**Rover Service News Letter No. 51**

January, 1955

**Rover Service News Letter No. 52**

Rover Service News Letter No. 53

Fig. 1. Layout of brake linkage.

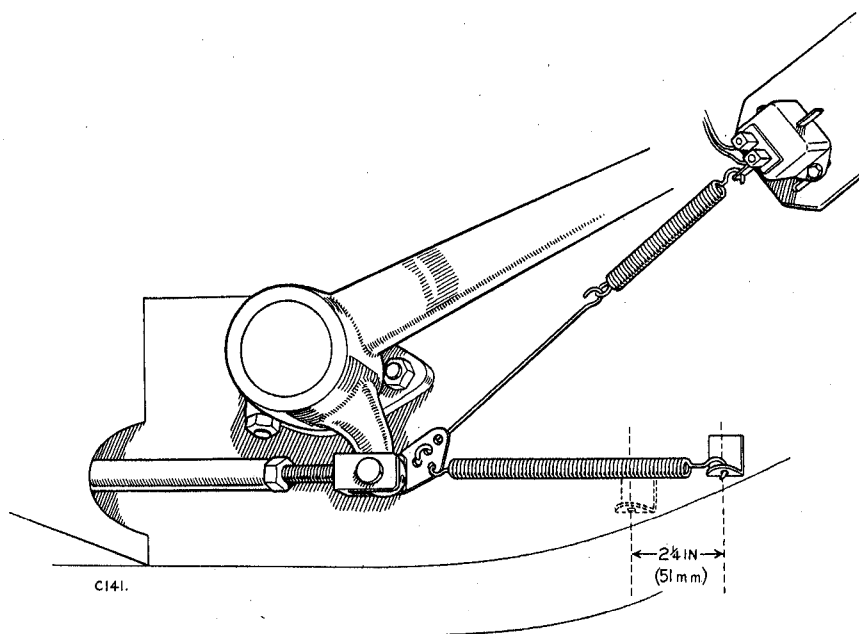
Any earlier 1954 or 1955 '60', '75' and '90' Car can be modified if so desired, by carrying out the following. See Fig. 1 below for layout of new parts.

5. Remove spring anchor from brake tube.
6. Weld a suitable bracket to chassis side member for the brake pull-off spring. The bracket to be approximately  $2\frac{1}{4}$  in. (57 mm.) forward of the original bracket, which should be removed.

9. Fit anchor plate (266270) to joint pin for fork end and split pin, discarding the original plain washer.
10. Remove brake stop lamp switch and bracket.

11. Fit bracket for stop lamp switch (266272) using original position on wing valance. Alternatively, the holes in the original bracket can be slotted to give adjustment to the stop lamp switch link.

12. Fit stop lamp switch and connect up link (266271) using a suitable hole in the anchor bracket, adjust link by means of the stop lamp switch.

Fig. 2. Backlight from L.H. side.

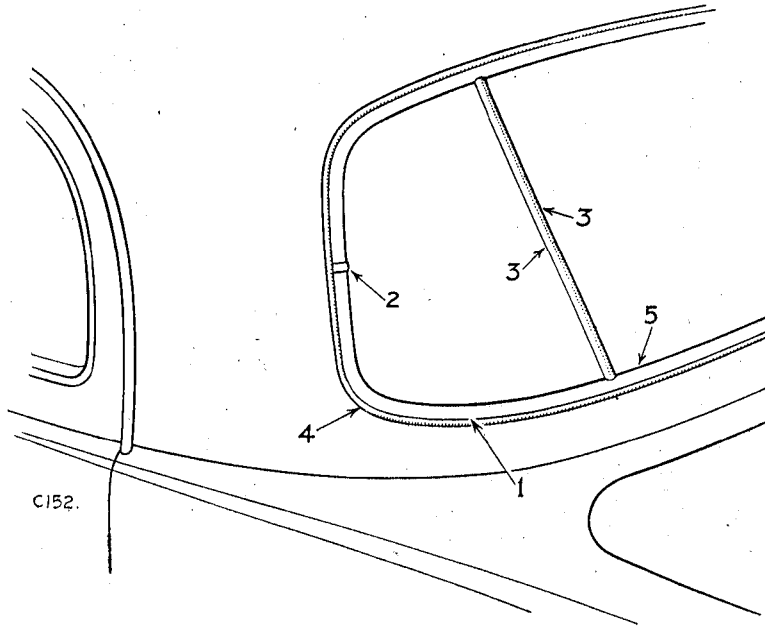
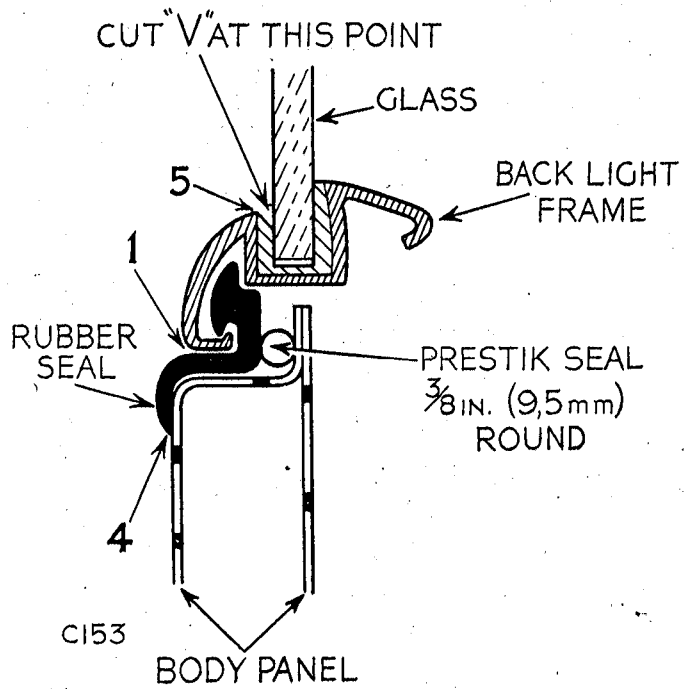
- (a) Using a suitable gun and nozzle inject Sealastik at the following points:—
- (1) All round the backlight between chrome bead and rubber seal. (See Figs. 2 and 3, Item 1.)
  - (2) Underneath the chrome clips at either side of the chrome beading. (See Fig. 2, Item 2.)
  - (3) Between backlight glass and vertical rubber seals. (See Fig. 2, Item 3.)
  - (4) All round backlight between rubber moulding and body. (See Figs. 2 and 3, Item 4.)
- (b) Cut a deep "V" in the rubber seal between glass and chrome bead and fill in with Sealastik. (See Figs. 2 and 3, Item 5.)

Fig. 4. Boot interior from left-hand side.

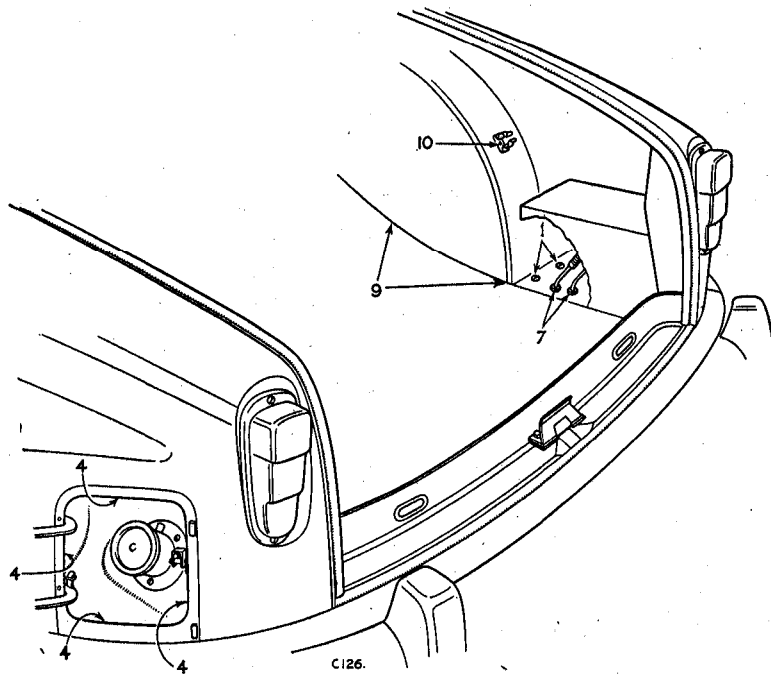
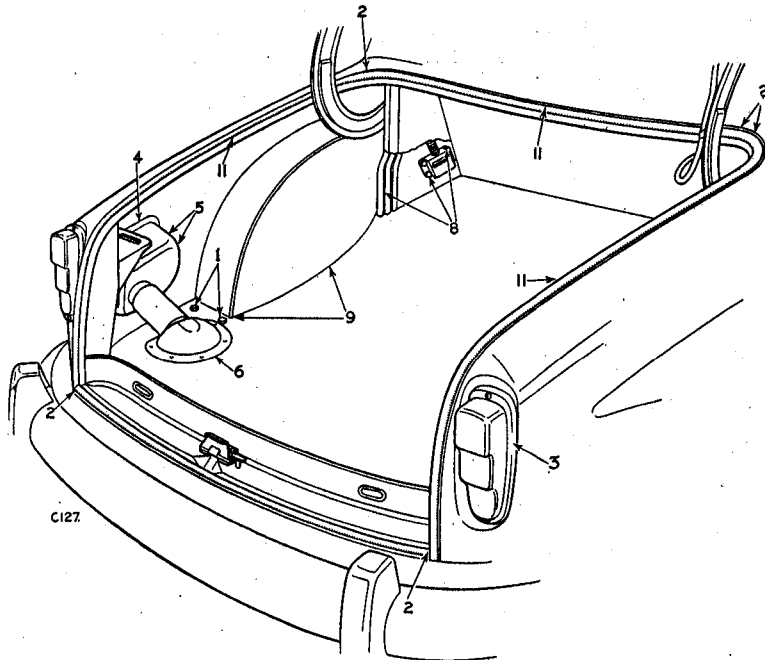
Remove the sealing rubber. Inject Sealastik all round the guttering, refit rubber and manipulate the rubber so that the lip protrudes above the wing line. (See Fig. 5, Item 11.)

Two cage nuts immediately behind L.H. wheelarch. Two nuts and bolts immediately behind R.H. wheelarch. Seal with Bostik. (See Figs. 4 and 5, Item 1.)

At the bottom of the gutters, and also through the welding at the top corners of the main boot lid sealing rubbers. Seal with Bostik where necessary. (See Fig. 5, Item 2.)

The body of the tail lamp, i.e., by-passing between the rubber seal and the wing panel. (See Fig. 5, Item 3.)

The petrol filler compartment—passing round the edges of the filler lid and between the panels and thence between the panel of the boxed-in section and the adjoining inner panel of the wing. The cut away edge of the boxed-in section panel should be sealed with a suitable compound. Seal off round the edges. (See Figs. 4 and 5, Item 4.)

The slots in the body, for the bolts holding the petrol filler lid hinge. Seal with Prestik washers. (See Fig. 5, Item 5.)

The flanges of the petrol filler neck where it adjoins the floor of the boot and petrol filler compartment. Seal off the edges with a suitable compound. See Fig. 5, Item 6.)

The petrol pipe grommets in the boot floor. Seal with Bostik. (See Fig. 4, Item 7.)

Four bolts in each wheelarch, holding the boot lid hinge support and three holding the trunnion bracket. Seal with Prestik washers. (See Fig. 5, Item 8.)

Between the junction of the wheelarch and the floor, seal with Bostik, especially at the corners, where the joint flange passes through the floor. (See Figs. 4 and 5, Item 9.)

Holes for the clip securing the wheel brace on the right-hand wheelarch. Seal with Prestik. (See Fig. 4, Item 10.)

Fig. 6. Front door pillar, left-hand side.

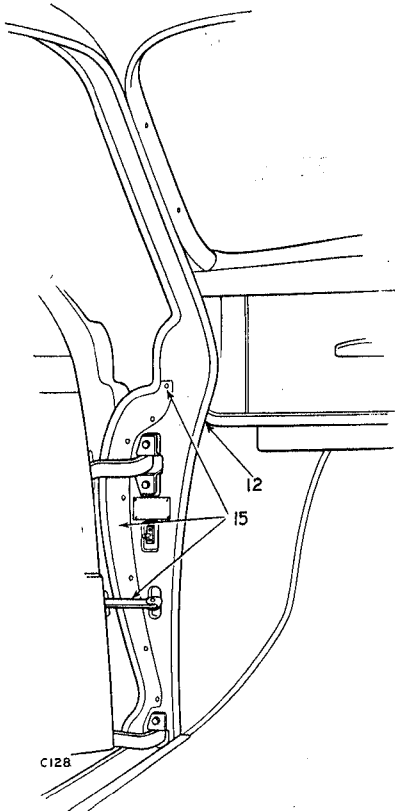
The sealing of the rubber retaining plates on the 'A' post should be checked from the top to the level of the door check straps; add sealing compound where necessary. (See Fig. 6, Item 15.)

Fig. 7. Scuttle, left-hand side.

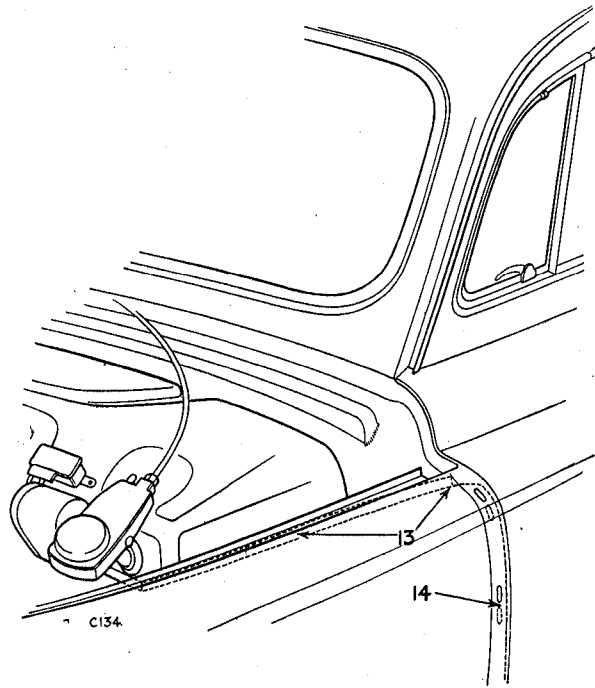
The spot welded seam, and the joint between the seam and the rear face of the 'A' post. Paint over with Bostik as necessary. (See Fig. 7, Item 13.) The angle for attaching the wing is bolted to the side of the dash by four set bolts. The slotted holes in the scuttle should be sealed with Prestik washers with 1½ in. (48 mm.) diameter aluminium washers on top; both being under the angle. (See Fig. 7, Item 14.)

Fig. 1. Dimensions of support bracket.

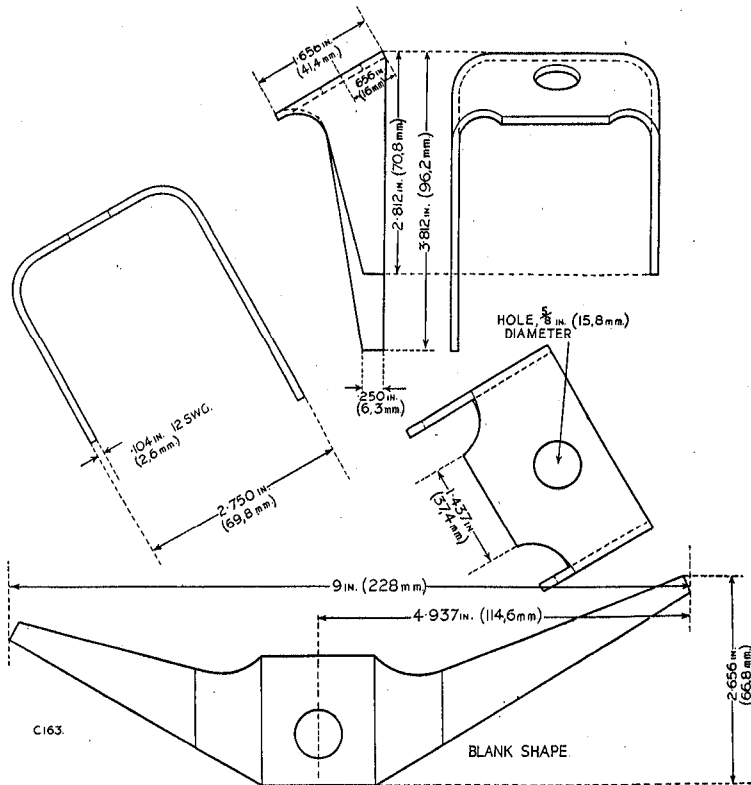
Some cases have been reported of the L.H. front engine mounting bracket on the chassis frame fracturing when the vehicle is used under adverse conditions. It is recommended therefore, that when a vehicle is being used under conditions which may cause the above complaint, that a suitable support bracket is welded on to the existing bracket at the first opportunity.

1. Drain cooling system.
2. Remove bottom hose, pump elbow to radiator.
3. Remove oil filter.
4. Remove nut, spring and plain washer from top and bottom of engine suspension rubber (on both sides of engine to ensure there is no stress put on the R.H. suspension rubber).
5. Support engine under sump and lift engine slightly.
6. Remove bolts and lock washers from L.H. engine support foot and lift out engine foot complete with rubber.
7. Make the support bracket reinforcement from mild steel to the dimensions shown at Fig. 1.

Fig. 2. Support bracket welded in position and parts reassembled.

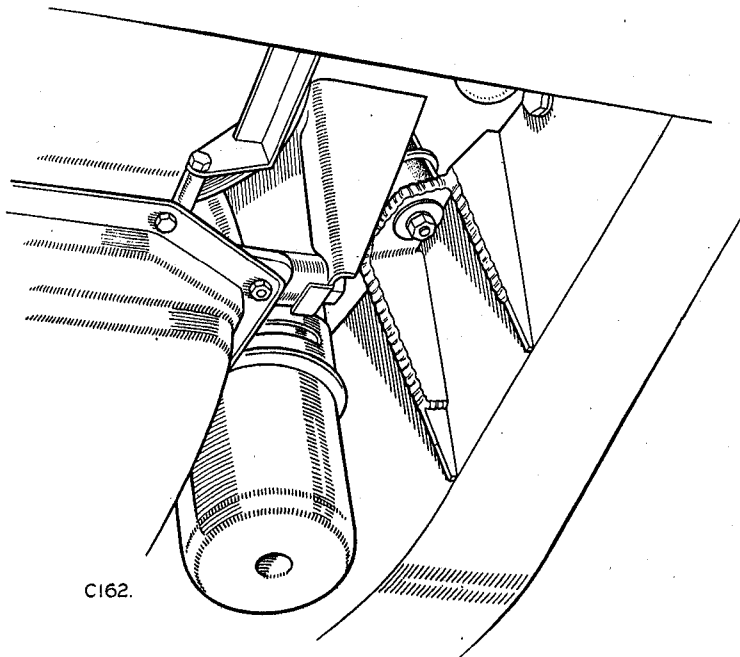
8. Offer up new support bracket and temporarily bolt into position.
9. Precautions prior to welding; insert asbestos sheeting between chassis and engine and between chassis and shock absorber.
10. Weld support bracket *on outside edges only*. This gives sufficient support to the bracket and minimises any tendency to distort the chassis frame.

Fig. 1. Piston identification.

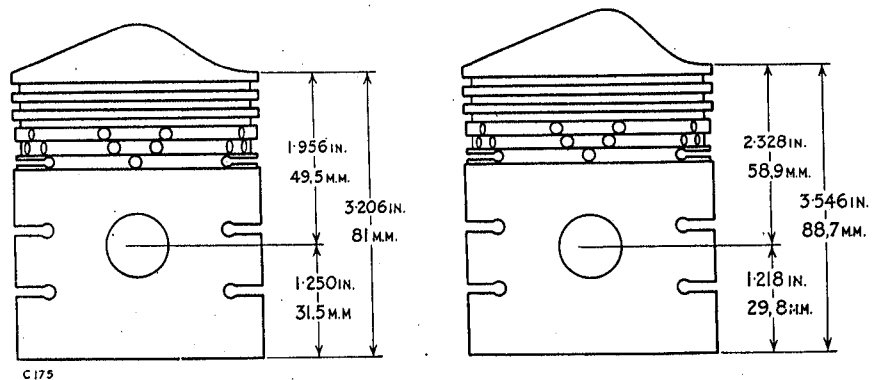
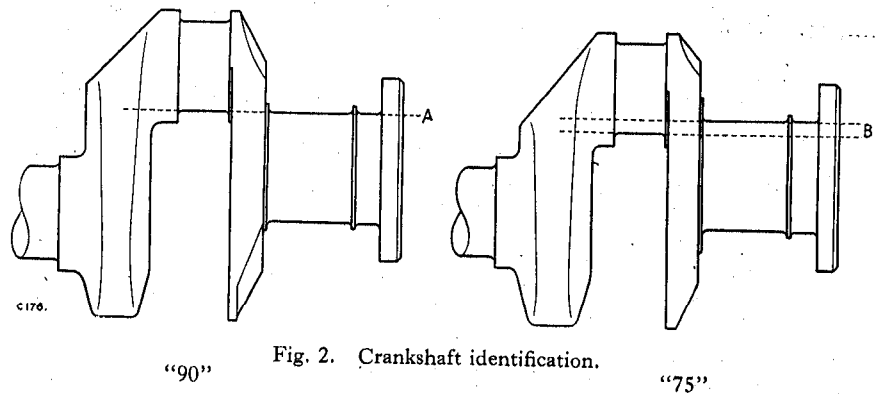
- Item 117 SUBJECT: PISTONS AND CRANKSHAFT.**  
**MODELS:** 1954-55 "90", 1955 "75".  
**REMARKS:** As the cylinder bore size of the 1954-55 "90" and the 1955 "75" is exactly the same, with little difference in the overall height of the piston, and with the basic dimensions of the crankshaft identical; it follows that stock can easily be confused if only a superficial examination is given when binning, supplying or fitting these parts. Great care must be taken to ensure that the correct type of piston and crankshaft, for the model concerned, is supplied and fitted when engines in the above range are being overhauled.
- It is possible to fit the wrong pistons or crankshafts in either model and this could of course have disastrous results. The sketches below clearly show the means of identification of the two types of piston and crankshaft.

Fig. 3. Order of tightening cylinder head bolts. (“75” and “90” models with steel cylinder head gasket)

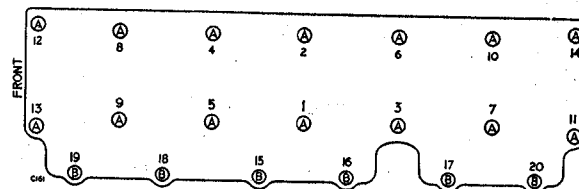
After tightening down the cylinder head bolts in the order and to the specified torque as shown at Fig. 3 a re-check of the torque figures must be made.

This operation is necessary to counteract reduction in torque of adjacent bolts during initial tightening owing to flattening out of the corrugations.

Bolts A to be tightened to 50 lbs./ft. (7 mKg.)  
 Bolts B to be tightened to 30 lbs./ft. (4 mKg.)

Fig. 4. Land-Rover chassis frame showing body angles—"A".

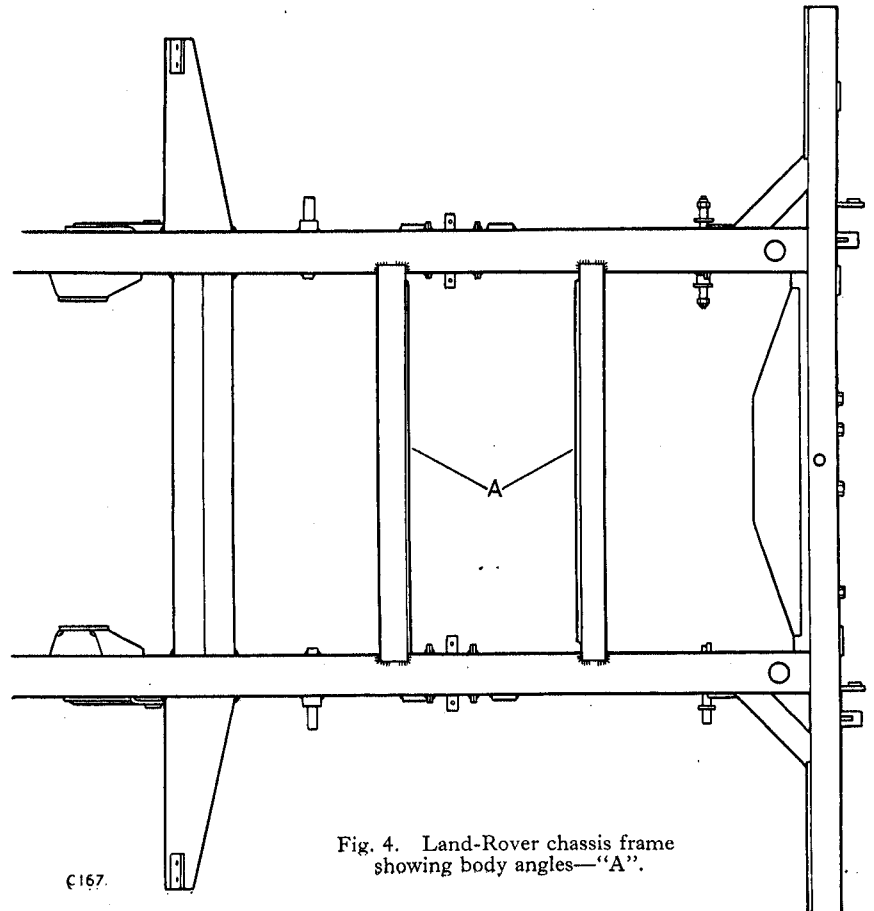
REMARKS: Future supplies of chassis frame Part No. 236805 will be complete with the body support angles suitable for the 1952-53 Land-Rover. When using these chassis frames on 1950-51 models, in the range detailed above, it will be necessary to remove those body support angles marked "A" in the sketch below.

Fig. 5. Basic attachment bracket and towing jaw supplied with each Land-Rover, showing alternative positions for the towing jaw. Part numbers as detailed above.

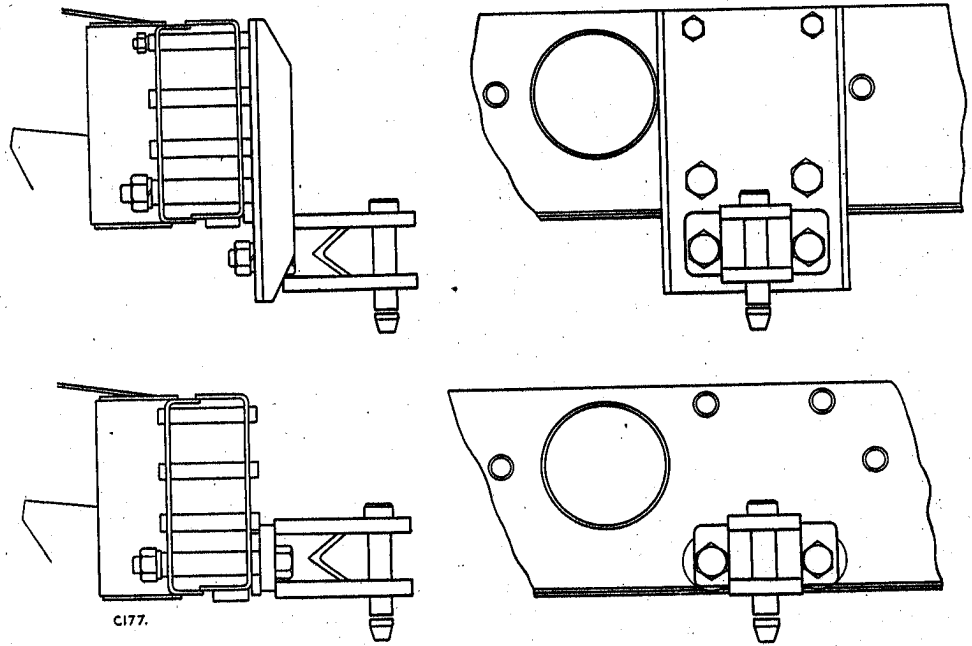
MODIFICATION: Introduction of revised towing attachment as detailed below:—

For your information we show in the following sketches the various towing attachments which are available together with the Extra designation, where applicable, and Service part numbers.

Fig. 8. Rear tow plate.

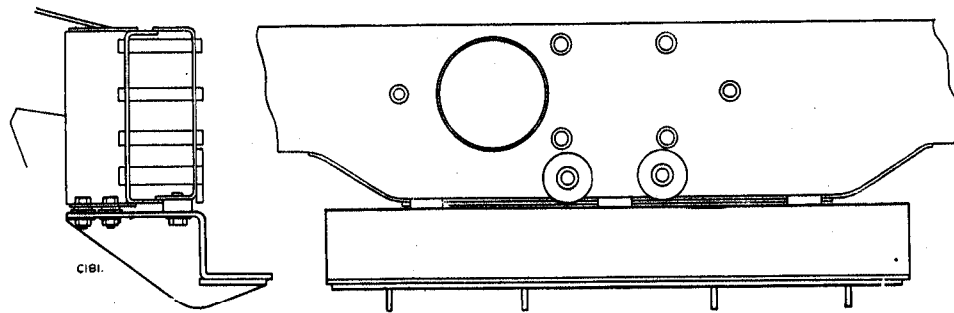
This item, which is now an Extra, was formerly supplied as part of the basic vehicle.  
Extra designation E.109. Service part number 265088.

Fig. 9. Rear tow plate must be used, in conjunction with the tow plate illustrated at Fig. 8, when the rear power take off drive is fitted and the basic towing jaw is also required.  
Service part number 231213.

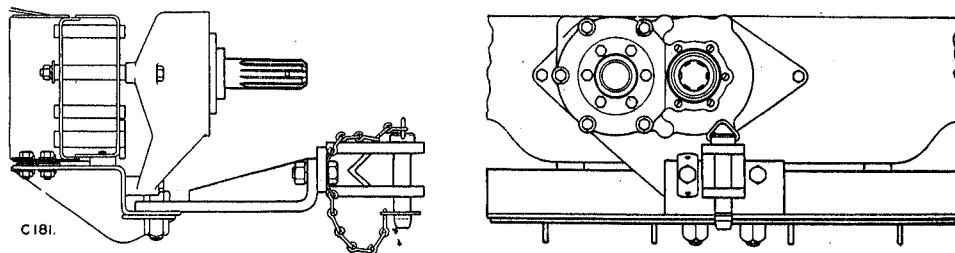
NOTE.—Future supplies of the rear power take-off will include the rear tow plate, part number 265088.

Fig. 1 Identification of sealing rubbers.

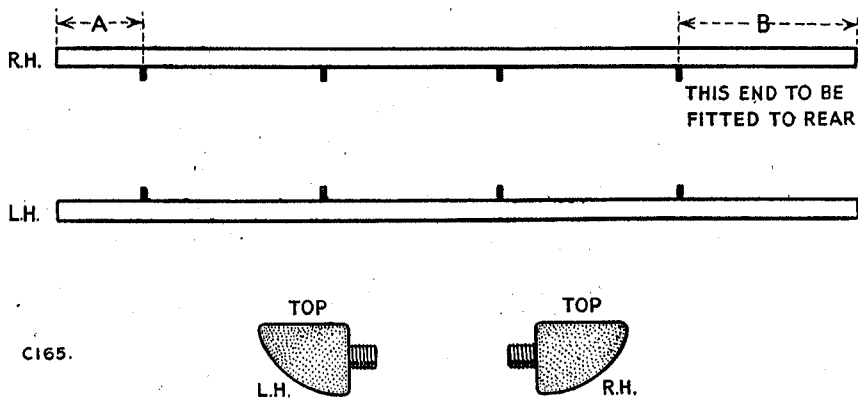
**MODIFICATION:** Improved sealing rubber for doors

1. Remove old rubbers, clean out channels. It will be necessary to open out channels in order to fit new rubbers.
2. The two front sill rubbers are interchangeable either R.H. or L.H., but rear rubbers are handed due to the difference in the position of the studs as shown at 'A' and 'B', Fig. 1. Dimension 'B' must be fitted to the rear of the car.

3. The rubbers must be fitted with the flat surface upwards, as shown at Fig. 1.
4. Place rubber in position at channel and mark off position of holes.
5. Drill holes in channel (No. 7 drill .201 in.) and fit rubbers, using the nuts and spring washers.
6. Excess rubber to be trimmed off after fitting.

Fig. 2. Showing position of hole for rubber grommet in petrol pump cover.

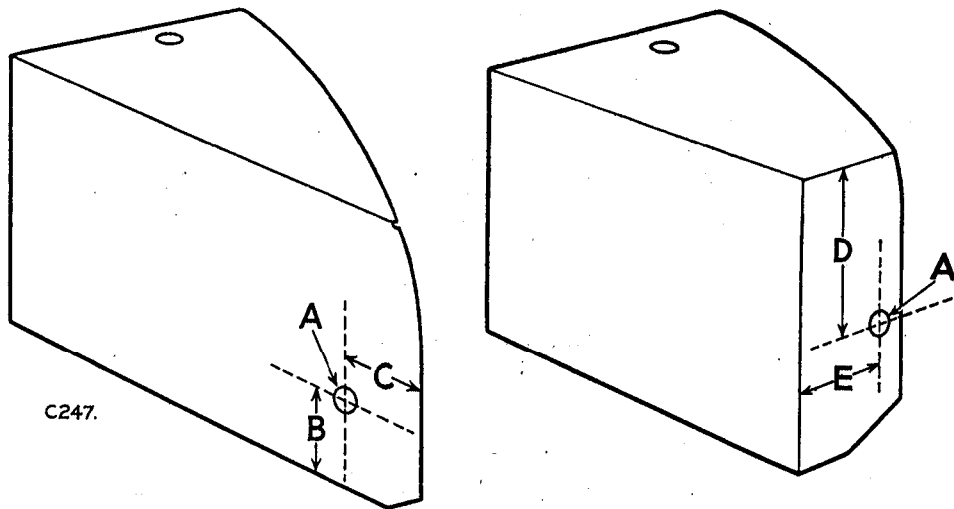
'A'— $\frac{1}{8}$ in. (16 mm) hole	} 1952-53 '75'	'A'— $\frac{1}{8}$ in. (16 mm) hole	} 1954-55 '60', '75' and '90'
'B'—2 in. (51 mm)		'D'— $3\frac{1}{4}$ in. (84 mm)	
'C'—2 in. (51 mm)		'E'— $2\frac{3}{8}$ in. (60 mm)
